SUBJECT: Forwards revised figure where approx 18 square ft area around PGCC column replaced w/Richlite floor plates in fire protection sys to eliminate personnel safety hazard. Addl matl does not compromise GE rept.

December 13, 1983
G02-83-1155

Subject: NUCLEAR PROJECT NO. 2
FIRE PROTECTION - RICHLITE PGCC FLOOR PLATES

FIGURE 2 CONTROL ROOM
LAYOUT

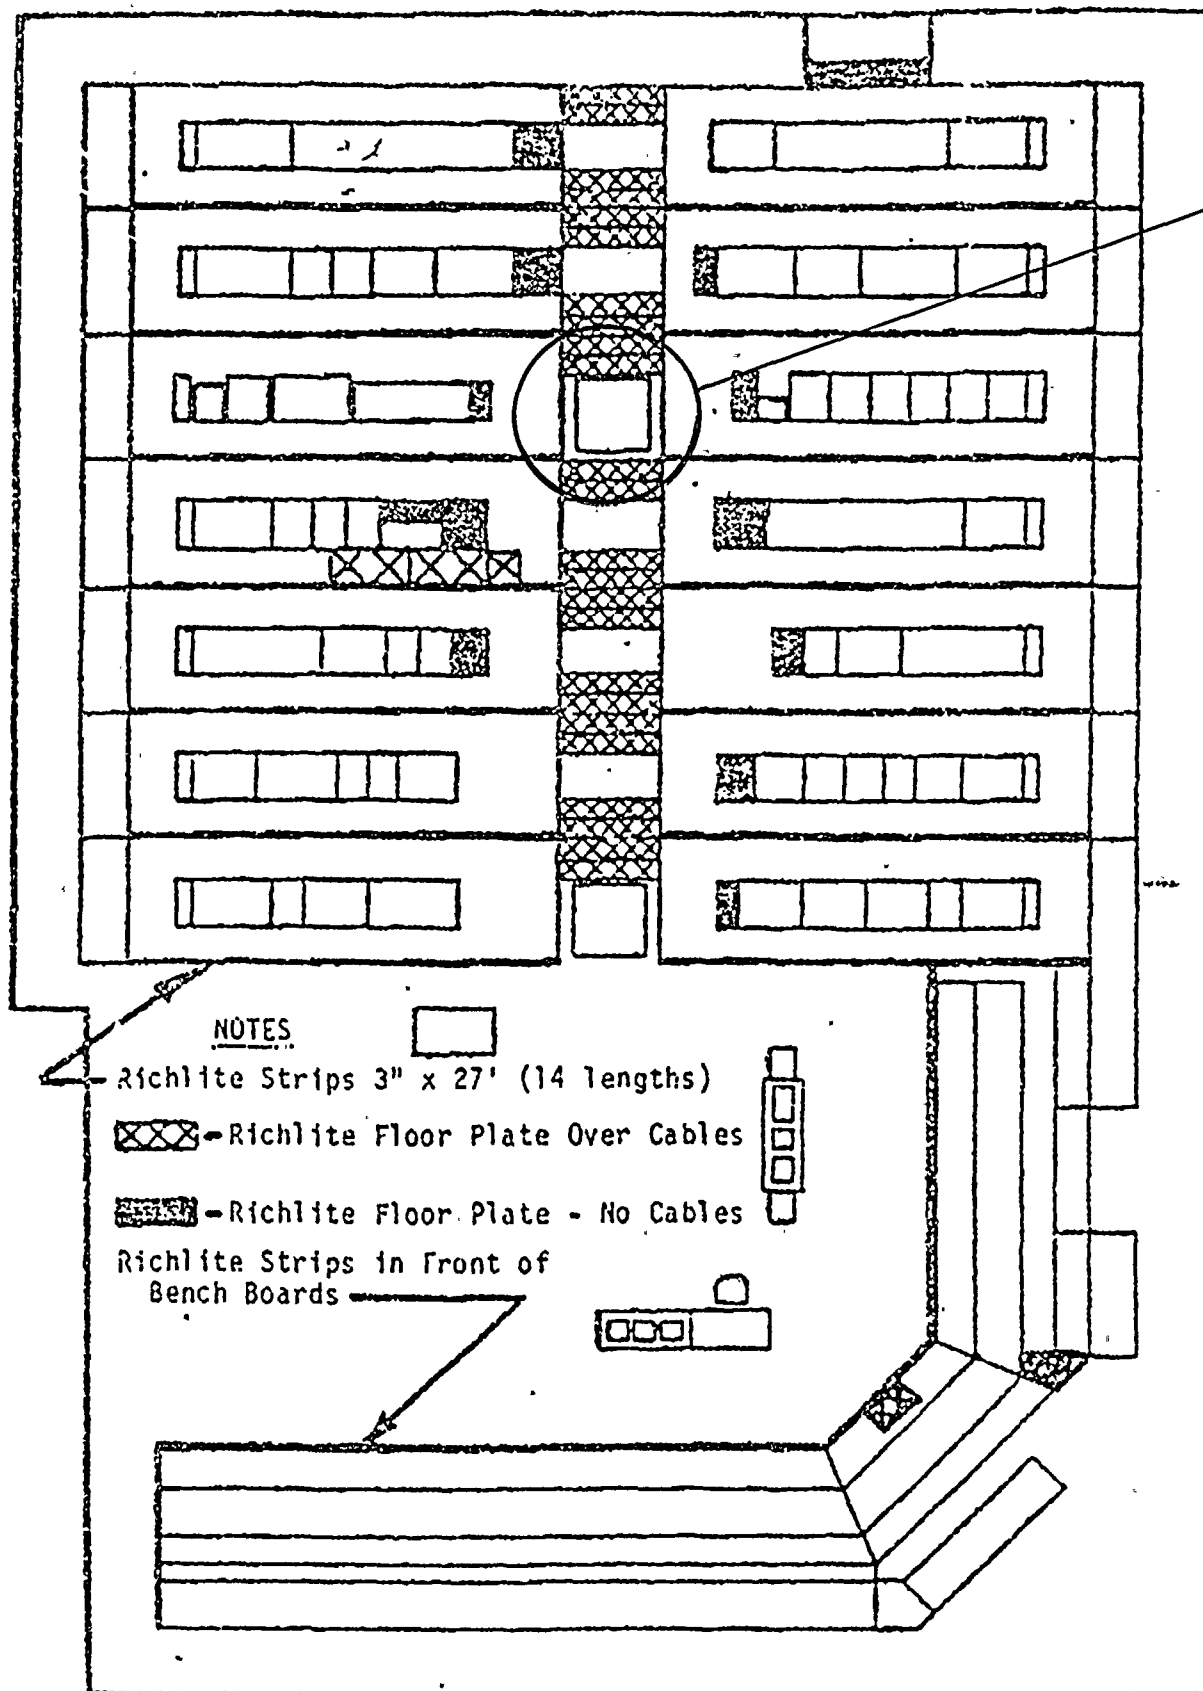
An approximately 18 square foot area around a column in the PGCC has been replaced with Richlite floor plates to eliminate a personnel safety hazard. This area is shown in the attached revised figure, which was part of the reference letter that included the GE report on the PGCC. The additional Richlite material does not compromise the GE report which states that only approximately 4% of the PGCC contains Richlite floor plates.

AREA
AROUND
COLUMN
REPLACED WITH
RICHLITE
